SERVICE PARTS LIST FOR MITSUBISHI ELECTRIC PACKAGED AIR-CONDITIONERS

Series : PEFY-P•NMHSU-E

REVISED

BWE1133D

PEFY-P72NMHSU-E

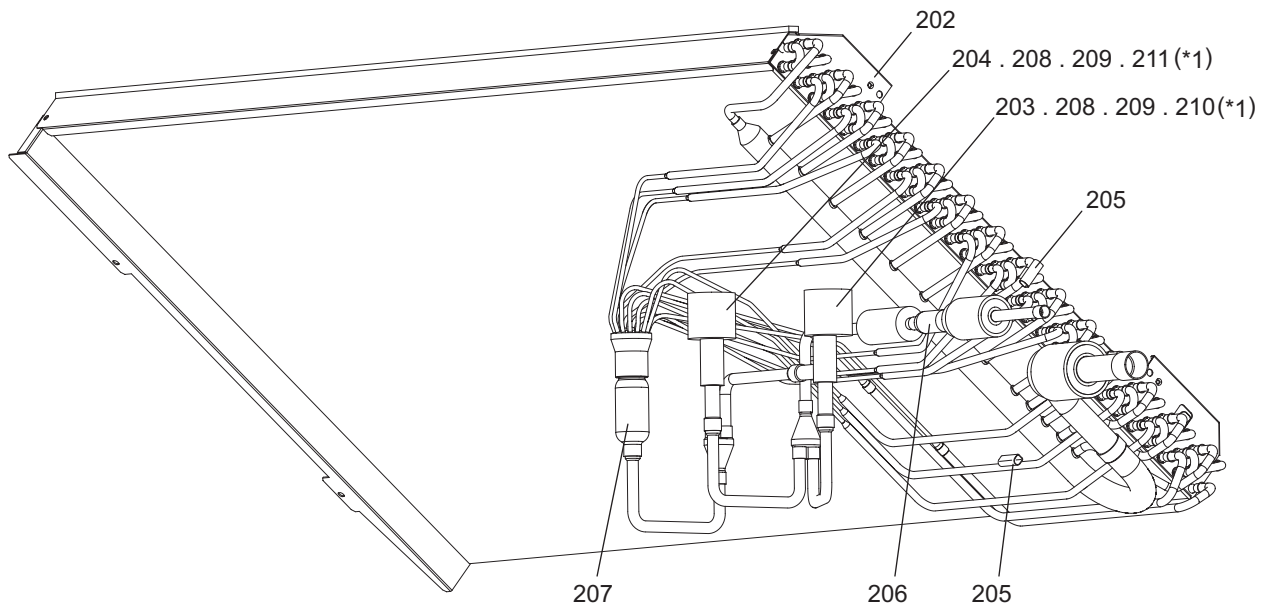
*1 Products manufactured to Sep. 2019 use EFM type LEV,
and products after Oct. 2019 use PAM type LEV.
In case of EFM type LEV is used, please change to PAM type LEV.
In that case, replace it with a set of 203 , 204 , 208 , and 209 .
Please order 210 and 211 when replacing only the motor part with EFM type.

BLOWER PARTS

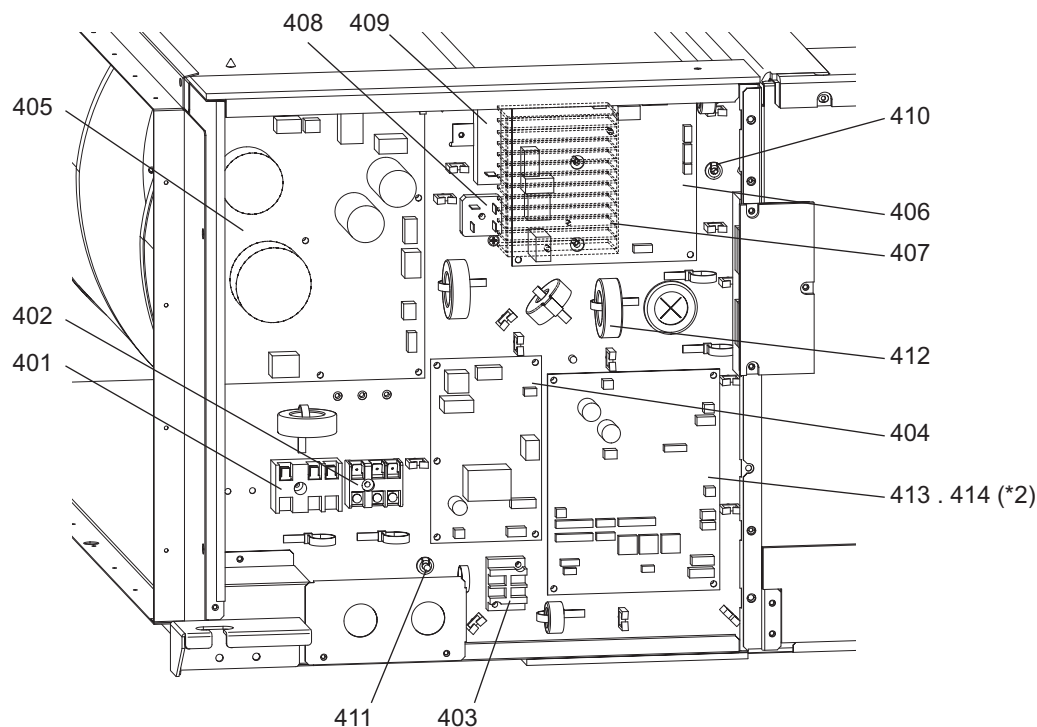
*2 For the products whose serial number is 5XW***** or later, be sure to use No.414.
For the products whose serial number is 59W***** or earlier, No. 413 or No. 414 can be used.
If the production number of the indoor unit is not available, procure parts No. 414 .
No. 413 will be supplied as long as the stock is available,
and only No. 414 will be supplied after the existing stock of No. 413 is depleted.

~59W*****	5XW*****~
No.413	USE	NOT USE
No.414	USE	USE
